# NOTICE OF DECISION

**CLASS 3 SITE PLAN REVIEW / CLASS 2 ADJUSTMENT CASE NO.: SPR-ADJ24-18**

**REQUEST:** A Class 3 Site Plan Review for a proposed redevelopment of an existing motor vehicle services use, including a new canopy and pedestrian connection to Commercial Street SE, with two Class 2 Adjustments to:

**Summary:** Proposed redevelopment of a canopy for an existing motor vehicle services use.

SITE PLAN

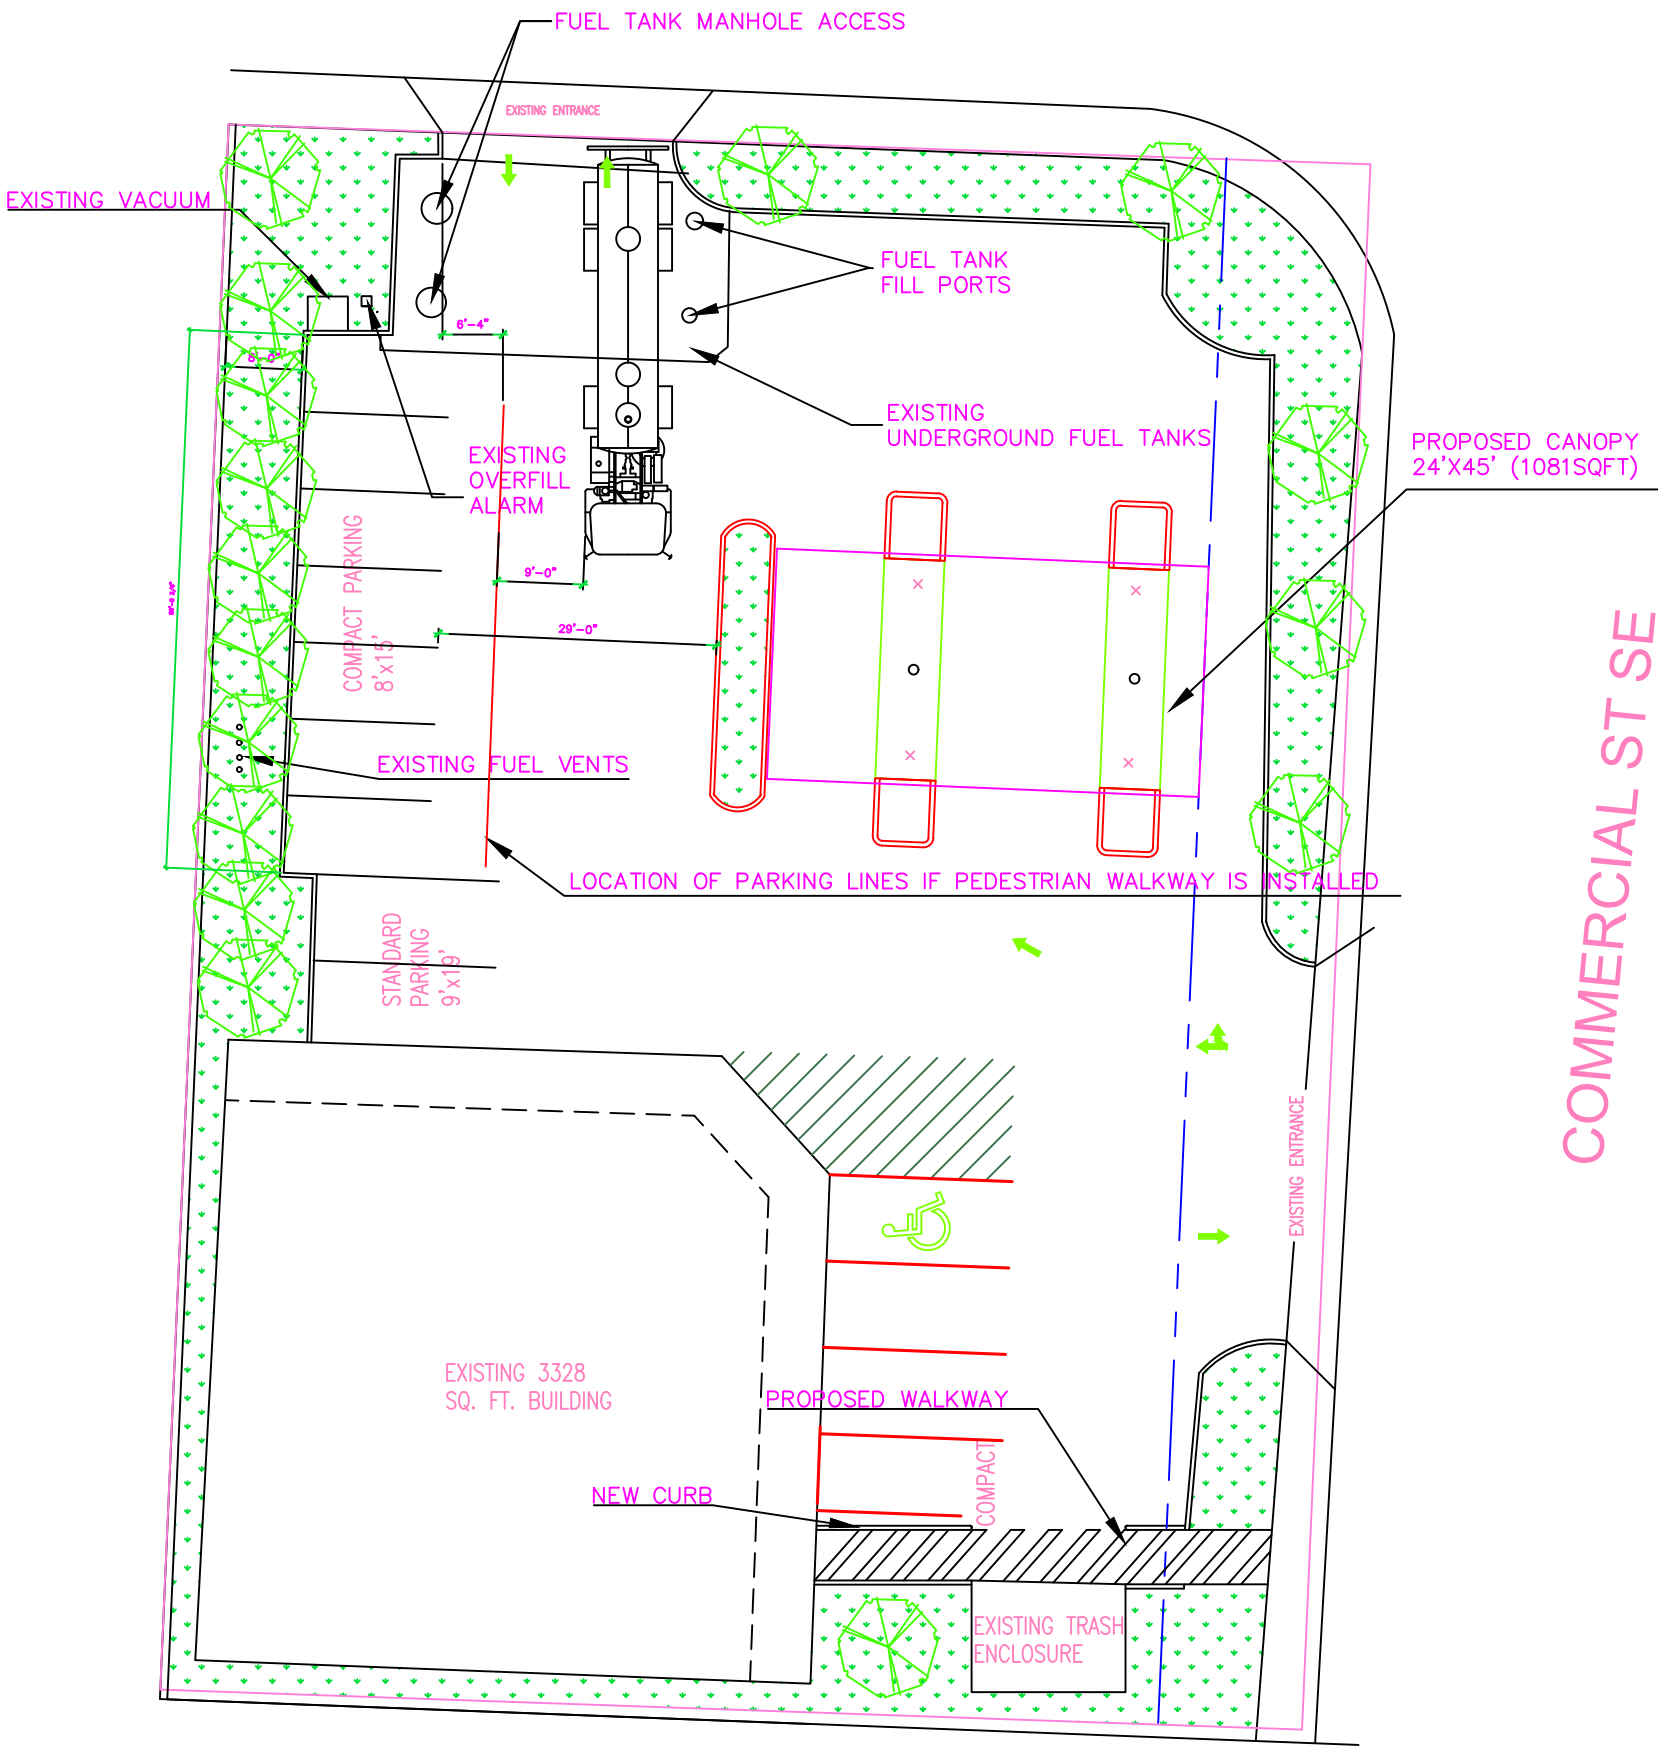
**Staff Response:** SRC 800.065 (a)(1) requires a development site to provide a pedestrian connection between each building and any abutting street. The standard would require the site to provide a pedestrian connection between the building and the abutting Commercial and Hoyt Street SE. As discussed below in Section 7 of this report, the applicant is seeking a Class 2 Adjustment to eliminate the required connection to Hoyt Street SE while providing a new pedestrian connection to Commercial Street SE. Currently, the site contained an existing striped pedestrian connection leading from the building to Commercial Street SE which did not meet design requirements of SRC 800.065.

In response to the comments provided by the neighborhood associations, the applicant submitted a revised site plan (**Attachment B**) correcting the dimensions of the western parking area to match the current layout of the property. Specifically, the previous plan showed that the stalls along the western edge of the property were full length 19 feet deep parking stalls and the landscaped setback being only five feet in depth when the stalls are currently compact with a depth of 15 feet and the landscaped setback is eight feet in depth. The applicant states that this reduces the capacity for the existing stalls to be modified in a way to allow the five-foot-wide pedestrian path without removing the stalls or eliminating existing established landscaping. In addition, moving the parking stalls eastward and establishing a pedestrian path between the existing landscaped setback and relocated parking stalls would project the stalls into the existing driveway approach onto Hoyt Street SE. Lastly, the applicant indicates that even with removing parking stalls, the pedestrian path would require the relocation of the existing fuel tank infrastructure. The existing overfill alarm is located within the landscaped area in northwest landscaped area and the fuel tank encompasses the area in front of the existing driveway approach and cannot be relocated.

**Finding:** The development plans indicate a new five-foot-wide pedestrian connection from the building's primary entrance to Commercial Street SE. The applicant is seeking a Class 2 Adjustment to eliminate a pedestrian connection to Hoyt Street SE which is addressed in Section 7 of this report. The standard is met.

**Finding:** The proposed pedestrian connection from the building to Commercial Street SE is a striped path five feet in width with a raised 5-inch curb separating the path from vehicle use areas. The proposal meets the standard.

**Finding:** The applicant's plans do not demonstrate conformance with the required lighting for the pedestrian paths, therefore the following condition applies:

In addition, to provide a pedestrian connection to Hoyt Street SE would require a reconfiguration of the northern parking area and pump station vehicle circulation while also requiring a relocation of fuel tank infrastructure. In response to the comments provided by the

neighborhood associations, the applicant provided a revised site plan correcting the dimensions of the western parking area to match the current layout of the property and adding additional details for the fueling tank infrastructure. Specifically, the previous plan showed that the stalls along the western edge of the property were full length 19 feet deep parking stalls and the landscaped setback being only five feet in depth when the stalls are currently compact with a depth of 15 feet and the landscaped setback is eight feet in depth. The applicant states that this reduces the capacity for the existing stalls to be modified in a way to allow the five-foot-wide pedestrian path without removing the stalls or eliminating existing established landscaping. In addition, moving the parking stalls eastward and establishing a pedestrian path between the existing landscaped setback and relocated parking stalls would project the stalls into the driveway approach onto Hoyt Street SE.

**Condition 2:** At the time of building permit, the applicant shall provide lighting along the proposed pedestrian pathway.
